ADDENDUM NO. 6 TO PROJECT NO. 44288

**CONSTRUCTION WORK, HVAC WORK, PLUMBING WORK, ELECTRICAL WORK
REPAIR UNDERGROUND STEAM TUNNELS
WILLARD DRUG TREATMENT CENTER
7116 COUNTY ROUTE 132
WILLARD, NY**

March 27, 2013

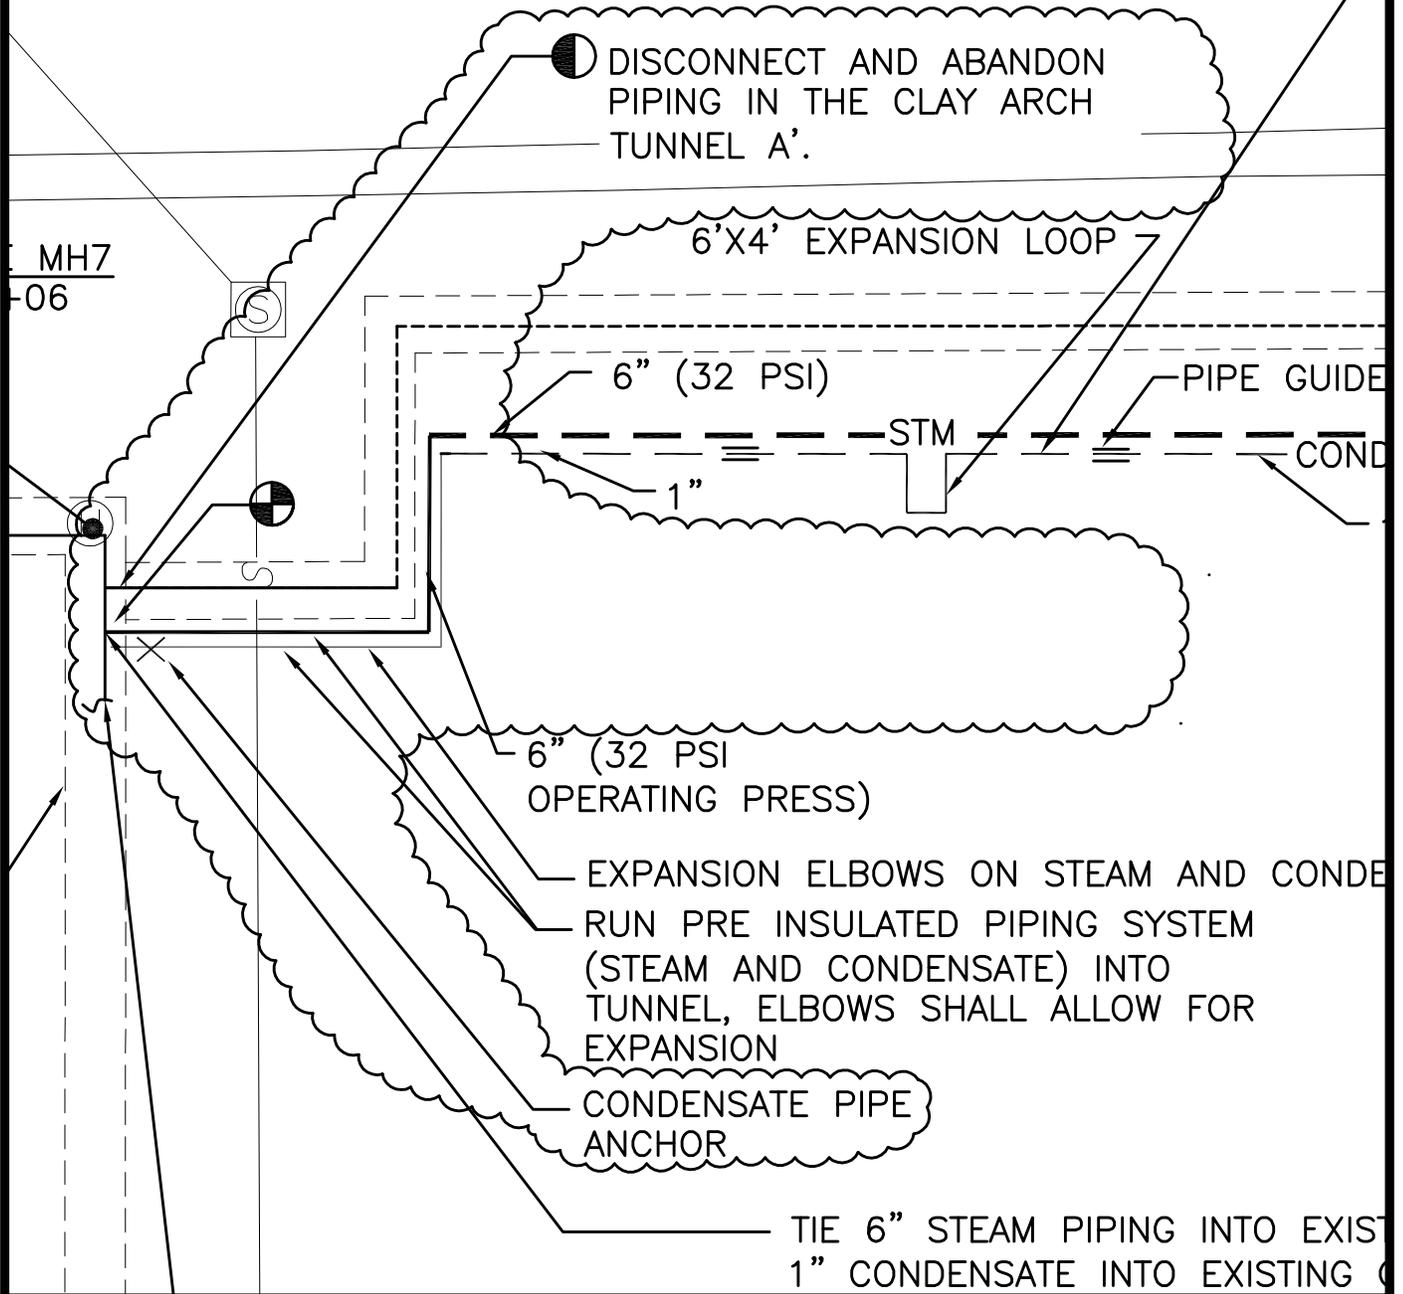
1. Drawing M-102 noted "REVISED DRAWING 2/22/2013": Modify the noted portions of the drawing with the accompanying drawings M-504 and M-505, dated 3/27/2013.

CONTRACTOR, REFER TO PIPING DETAILS ON DRAWING M-501. INSTALL PIPING AT SAME DEPTH (INVERT) AS THE STEAM PIPE.

DWG NO:
S-523

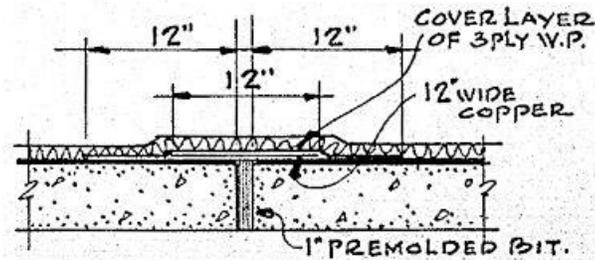
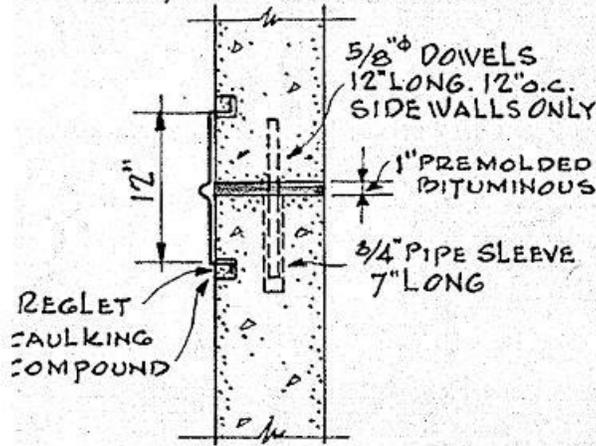
1. MINIMUM CLEAR DISTANCE BETWEEN STEAM PIPING AND THE TUNNEL WALL IS $3 \frac{3}{4}'' \pm$ WHICH OCCURS AT TUNNEL J. IN ALL OTHER TUNNELS, THE CLEAR DISTANCE IS A MINIMUM OF $5 \frac{1}{2}'' \pm$.
2. EXISTING CONDITION DETAIL IS FOR INFORMATION ONLY. JOINT WIDTHS VARY WITH EXPANSION AND CONTRACTION OF THE TUNNEL SYSTEM AND WERE OBSERVED TO BE BETWEEN $\frac{1}{8}''$ AND 2". THE PRESENCE OF COPPER FLASHING ON THE EXTERIOR OF THE TUNNEL HAS NOT BEEN VERIFIED.
3. DETAIL TAKEN FROM DRAWING 35-101, ENTITLED "TUNNEL DETAILS", PROJECT 4214, DATED AUG. 19, 1935.

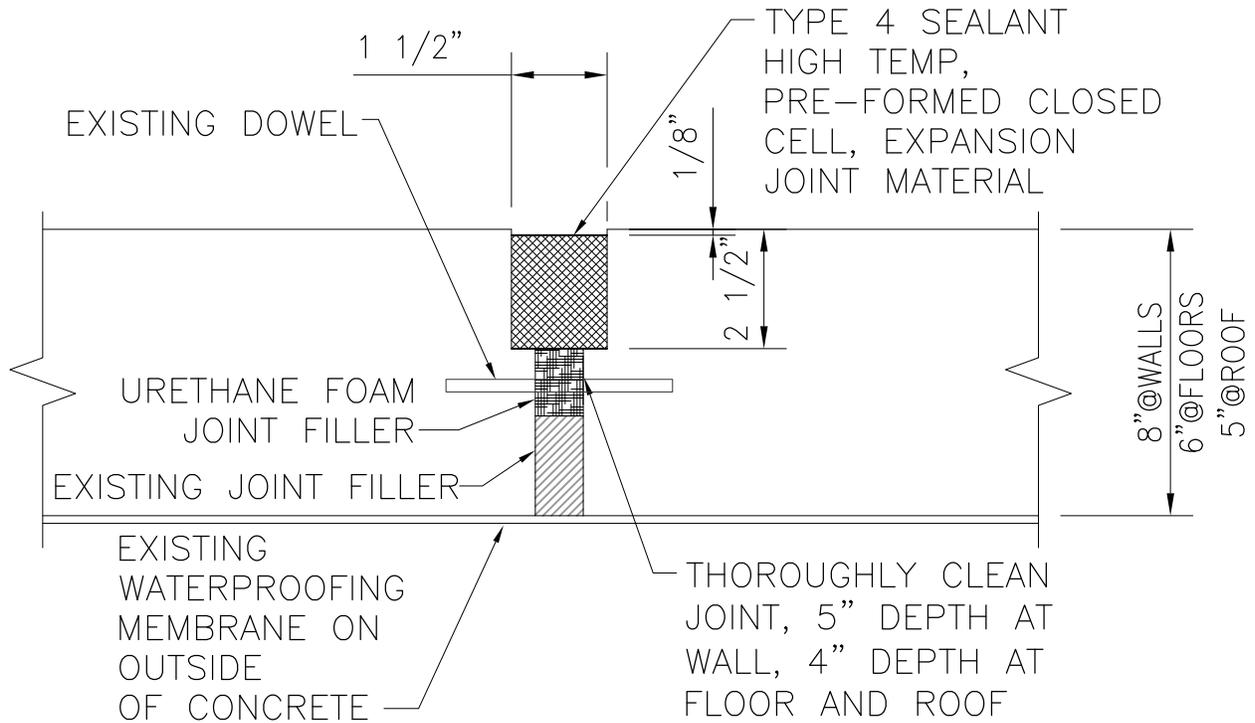
1. REFER TO URETHANE FOAM AND TYPE 4 SEALANT MANUFACTURER'S INSTALLATION INSTRUCTIONS FOR JOINT PREPARATION AND TOLERANCES.
2. THIS DETAIL FOR USE EXCEPT WHERE ALTERNATE JOINT REPAIR, ADDENDUM #6 DWG. S-525 IS USED

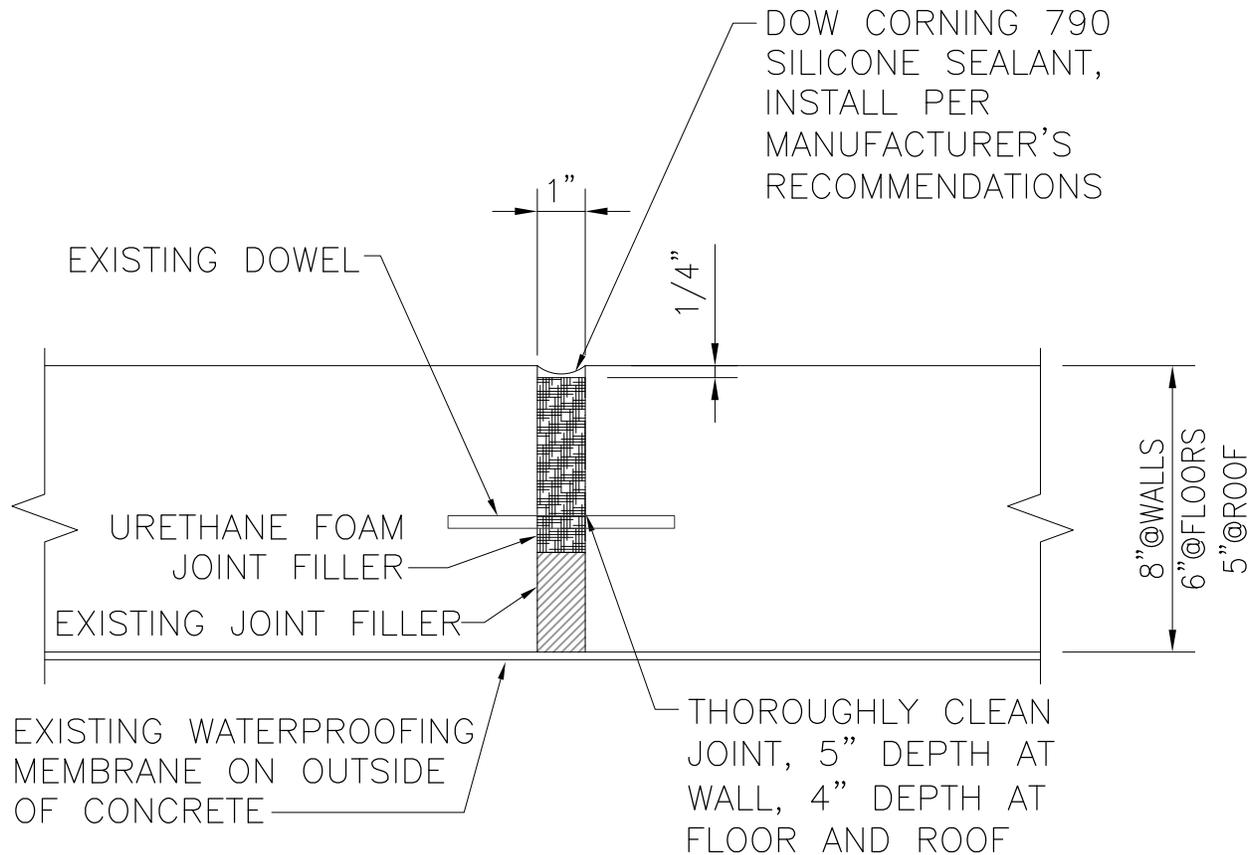
6. DRAWING S-501, noted "REVISED DRAWING 2/22/2013", Detail 1: Add note 4:
"4. REMOVAL REQUIRED TO BE GREATER THAN 2 1/4" WILL BE COMPENSATED FOR BY FIELD/CHANGE ORDER."
7. DRAWING S-501, noted "REVISED DRAWING 2/22/2013", Detail 3: Replace leadered note "1 1/2" CHAMFER" with "0" CHAMFER, FORM CONCRETE SURFACE FLUSH WITH ADJACENT SURFACE".
8. DRAWING S-501, noted "REVISED DRAWING 2/22/2013": Add the accompanying drawing S-523, dated 3/27/2013..
9. DRAWING S-501, noted "REVISED DRAWING 2/22/2013", Detail 6: Replace Detail 6 with the accompanying drawing S-524, dated 3/27/2013.
10. DRAWING S-501, noted "REVISED DRAWING 2/22/2013": Add the accompanying drawing S-525, dated 3/27/2013.

1. REFER TO URETHANE FOAM MANUFACTURER'S INSTALLATION INSTRUCTIONS FOR JOINT PREPARATION.
2. THIS DETAIL FOR USE IN LOCATIONS WHERE THE DIRECTOR'S REPRESENTATIVE DEEMS THE JOINT INACCESSIBLE FOR THE STANDARD JOINT REPAIR DETAIL ON ADDENDUM #6 DWG. S-524. THIS DETAIL IS TO BE USED AT 5% OF THE JOINTS.
